Our ref: DOC24/399724

Subject: Keri Keri Wind Farm (SSD-38358962)

ATTACHMENT A – BCS & NPWS Assessment Summary for Keri Keri Wind Farm EIS

Figure 1: Bionet records for *Pilularia novae-hollandiae* showing locations to the west of Deniliquin (5 July 2024).

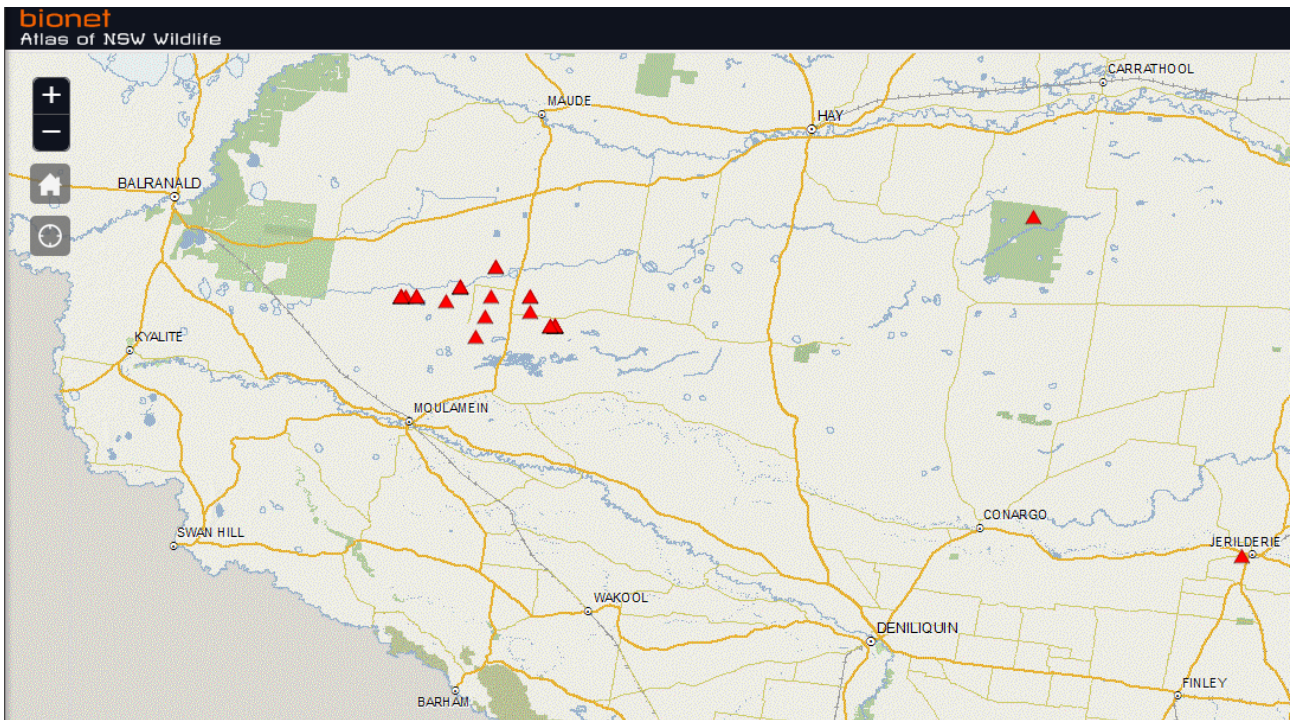
The accredited assessor has excluded the *Pilularia novae-hollandiae* from the assessment based on the subject land not being east of Deniliquin, NSW. While BCS acknowledges that the TBDC lists this as a constraint, this species has been recorded west of Deniliquin for other developments in the South West REZ (Figure 1).

- 11.1. Survey for *Pilularia novae-hollandiae* and complete a SAIL assessment.

Figure 3: Proposed tracks in proximity to existing tracks mapped in Figure 1.2 of the BDAR.

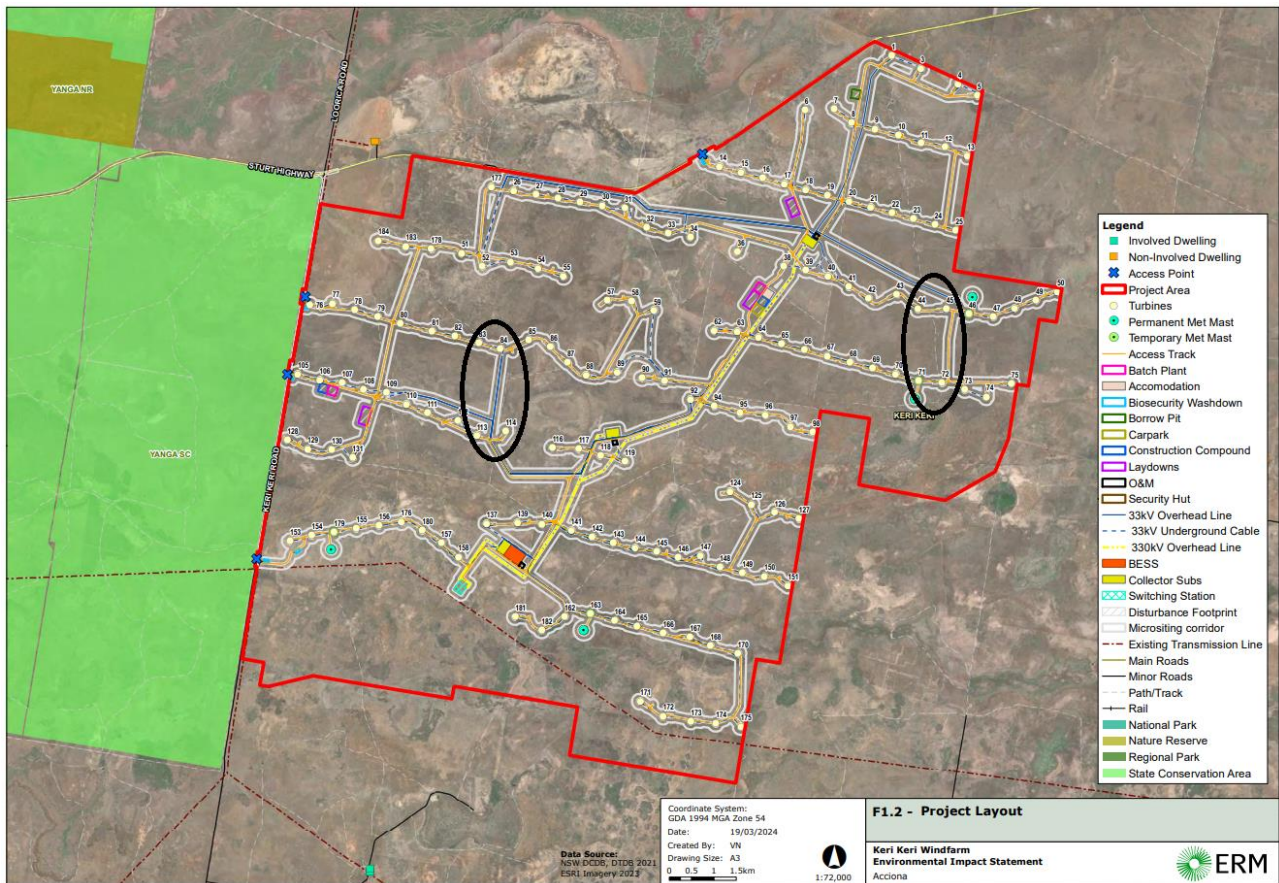
BAM 7.1.2(4) requires the BDAR to demonstrate that the routes have been selected to avoid or minimise impacts on biodiversity values and to justify why the proposed routes were selected. The proposed new track and cable reticulation trenching between some turbine locations does not appear to have been located to maximise the existing track network and avoid native vegetation. For example, in Figure 1.2 new tracks are planned between turbines 84 and 113 and between turbines 45 and 72. However, there are existing tracks close by that are not being used as can be seen circled below in Figure 3. BCS recommends the proponent revisits the proposed location of all tracks to ensure the existing network is used, and co-locating cable reticulation with the existing disturbance.

- 15.1. Provide detail for all avoid and minimise measures to be implemented through post-approval Environmental Management Plans (EMPs), in line with the requirements set out in BAM 7.1.2 and 7.2.2(2).
- 15.2. Document measures to minimise the impacts to raptors at the proposed turbines that are within 500m of recorded stick nests.
- 15.3. Document the difference in biodiversity impacts between the scoping layout and the layout presented in the EIS.
